ZONING BOARD OF APPEALS APPLICATION
City of Madison

**ZONING ADMINISTRATOR'S REPORT
VARIANCE APPLICATION
5042 Lake Mendota Drive**

Re: Side and rear yard setback variances for house addition, Lot 2, Block 3 Spring Park, 5042 Lake Mendota Drive.

RE: Petition Number M-08-74-97
5042 Lake Mendota Drive

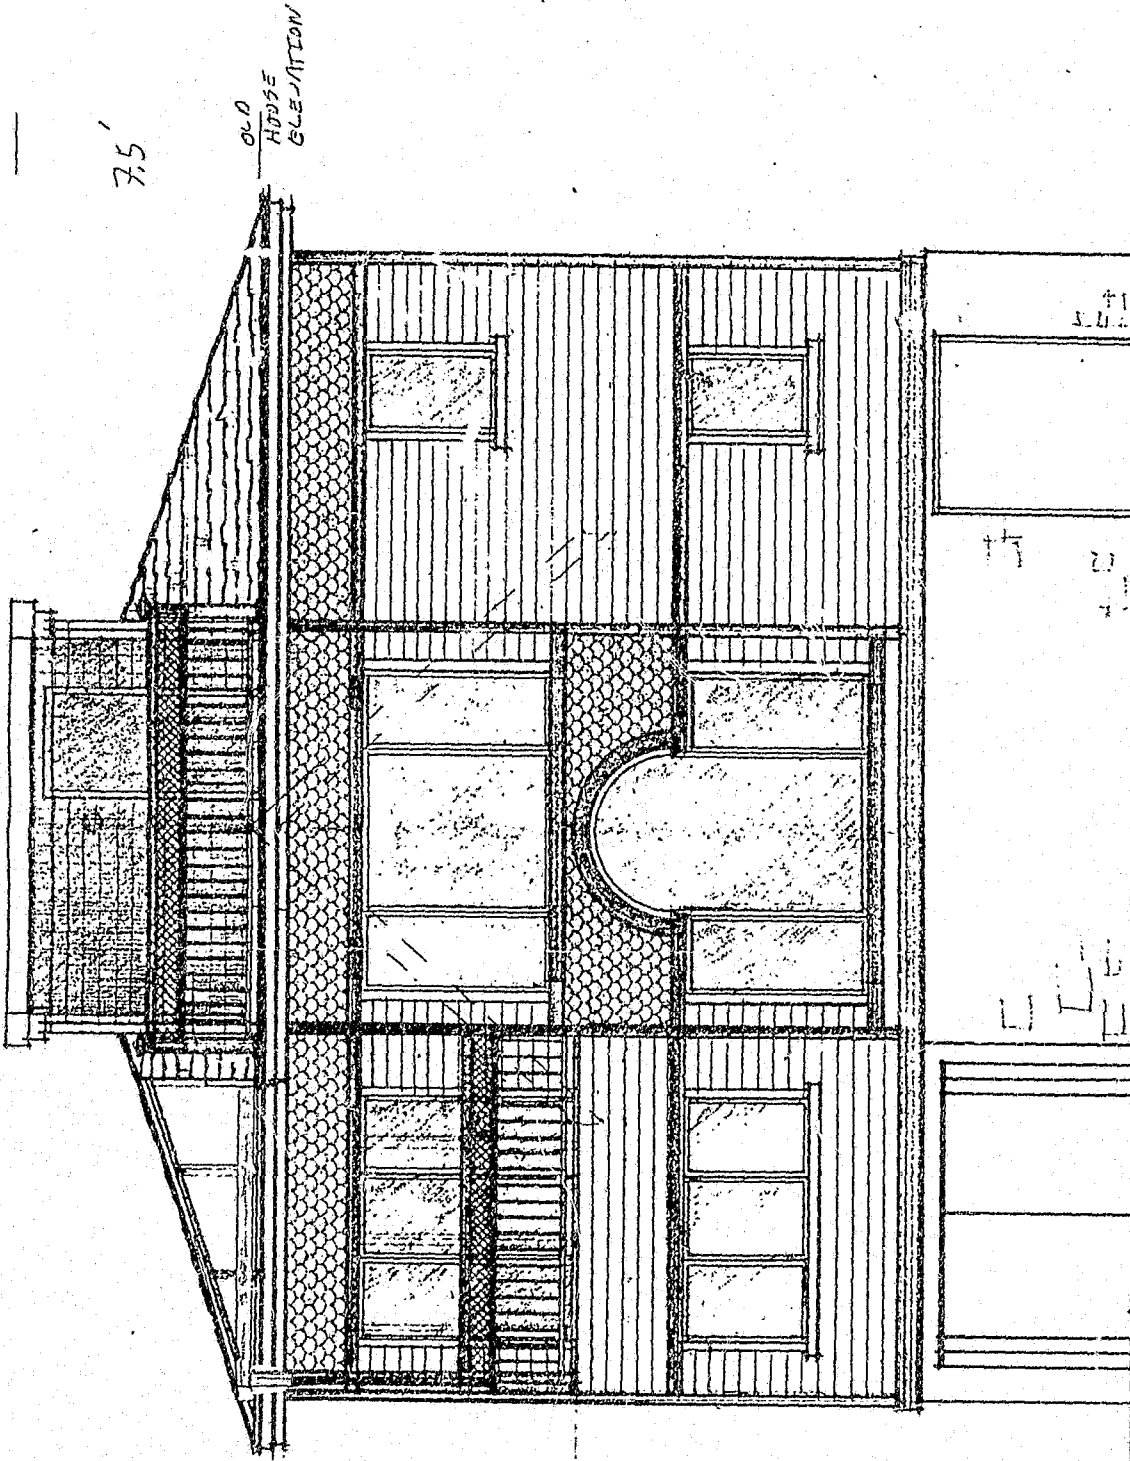
The Zoning Board of Appeals: (Approved) (Disapproved) (Conditionally Approved)
the request for a 6.7' minimum side yard variance and 15.7' total side yard variance
to construct a second-story addition onto the subject house which will be .3' from the
side lot line. A building permit is required.

Back Yard
O.K.

Minimum Side Yard
7' Required
3' Provided
6.7' Variance
Total Side Yard
18' Required
2.3' Provided
15.7' Variance

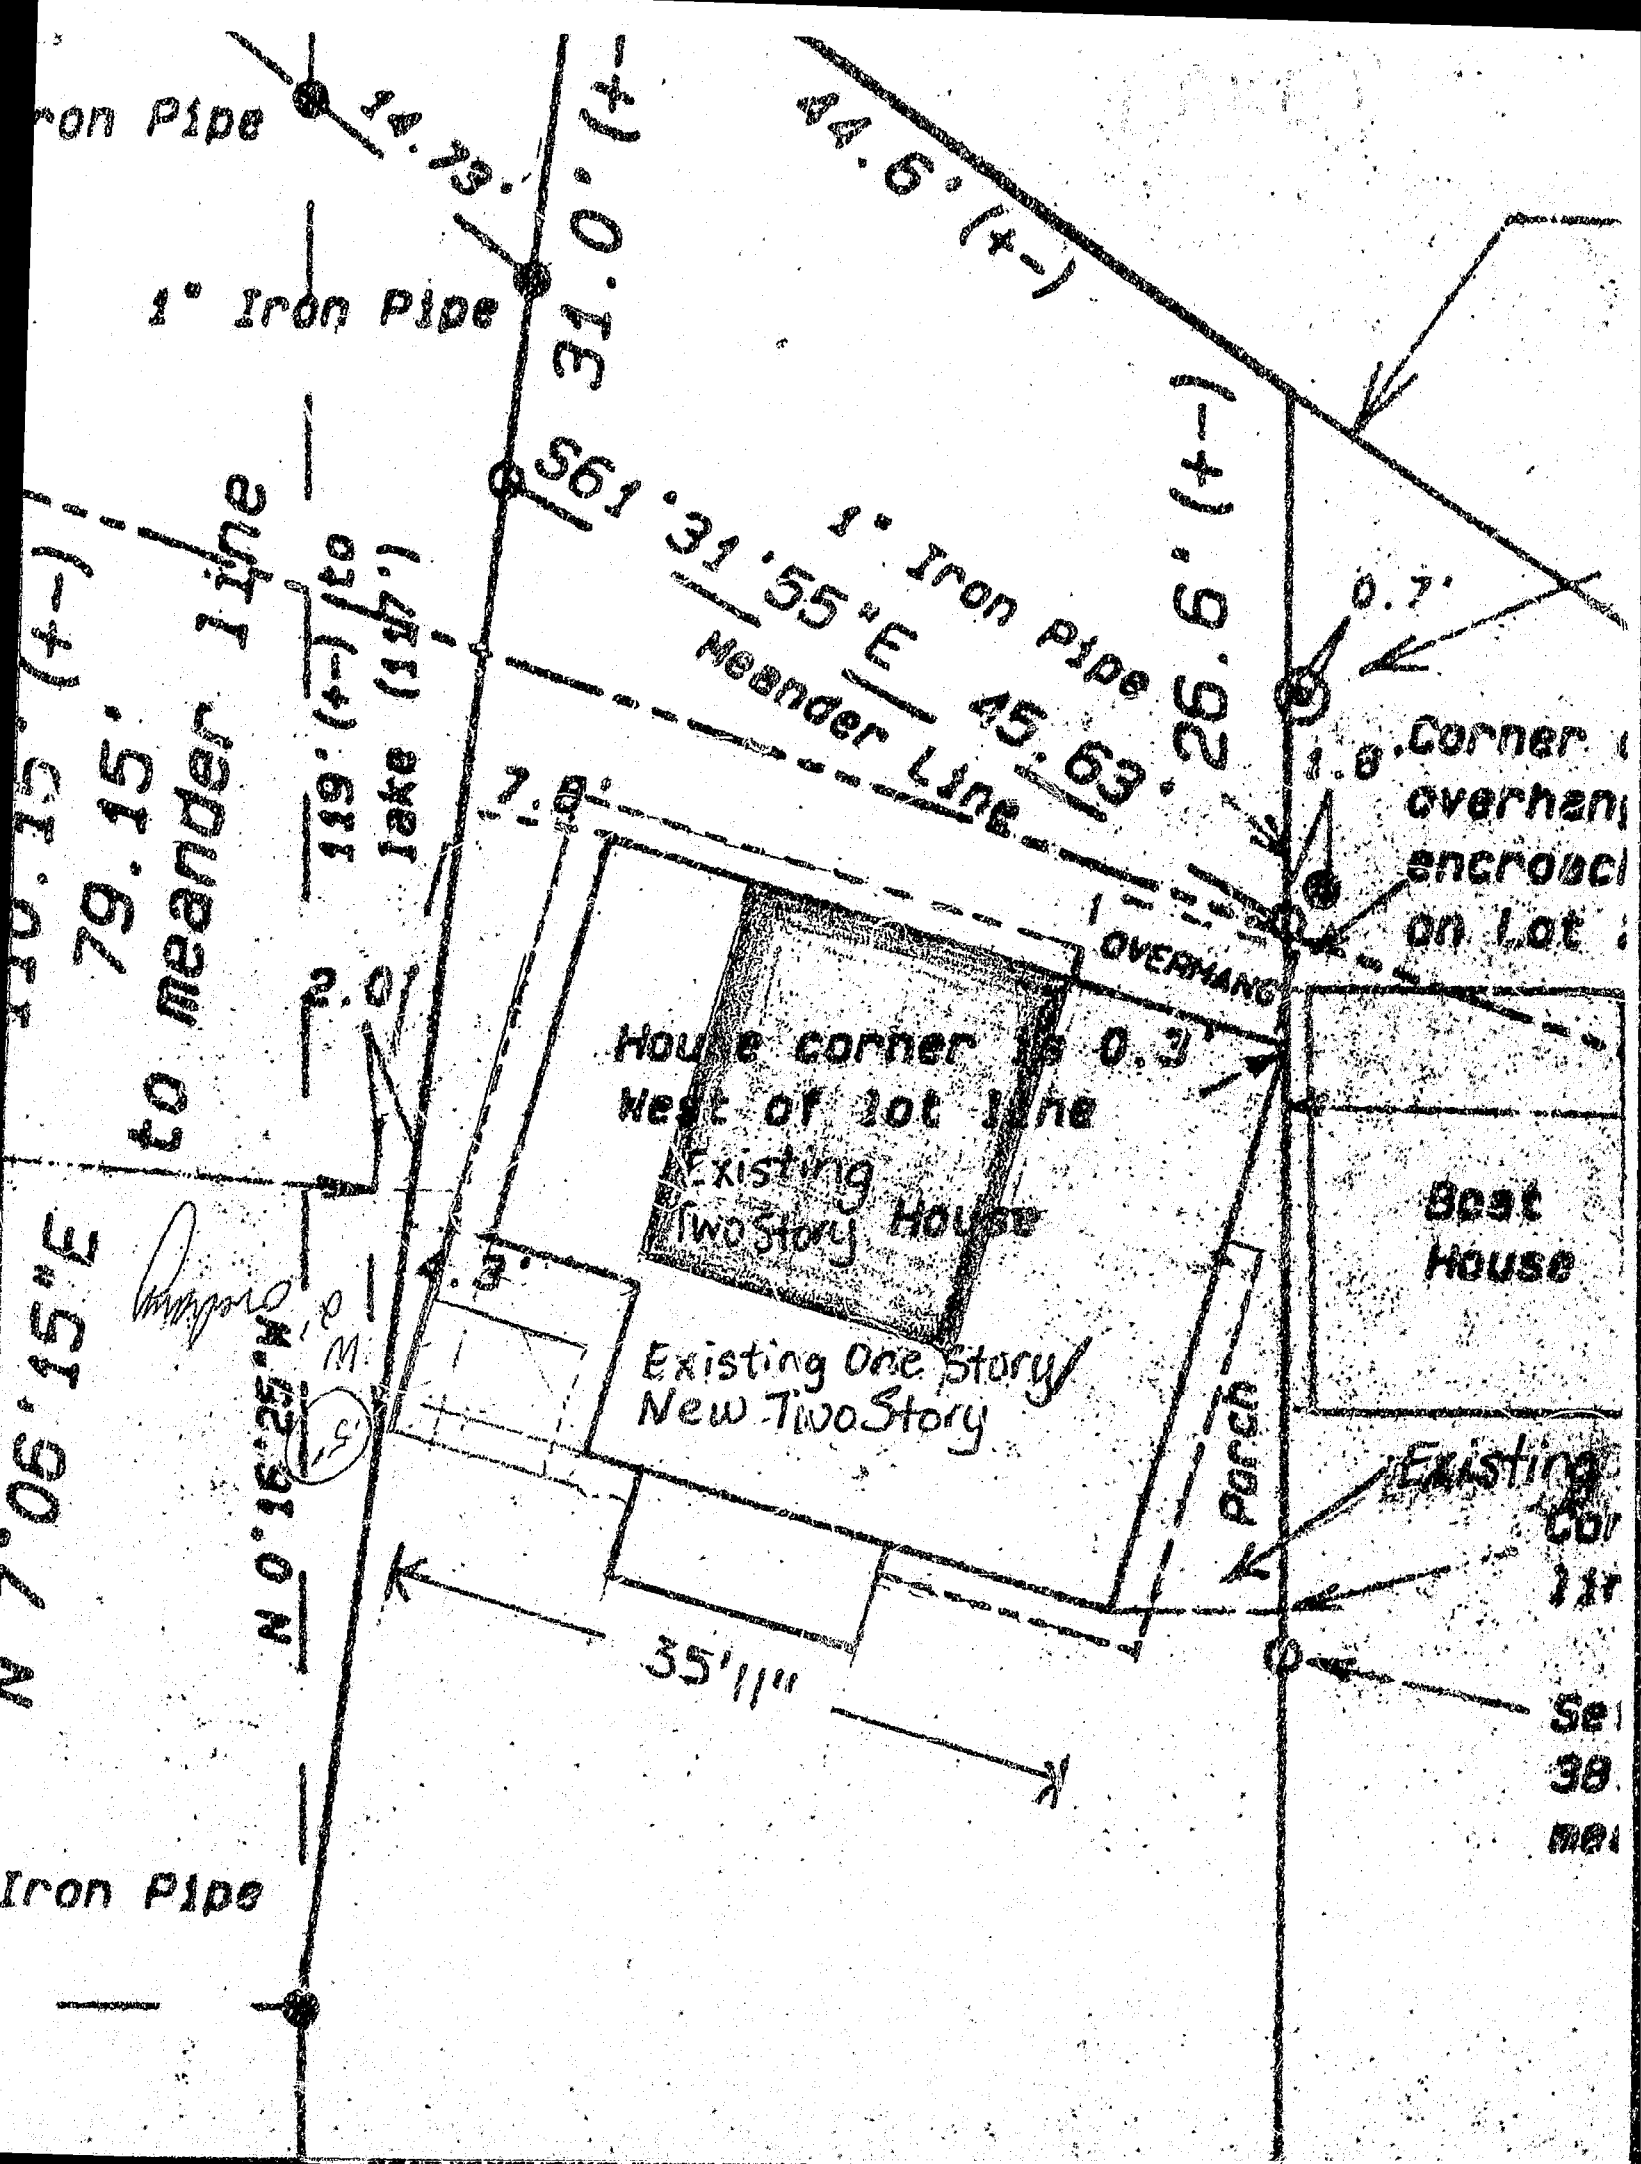
NO ENCLOSED
2ND
STORY

NO
EXTENSION
INTO
"EL"

OVERHANG
ROOF AT
REQUEST
OF
WEST
NEIGHBORS
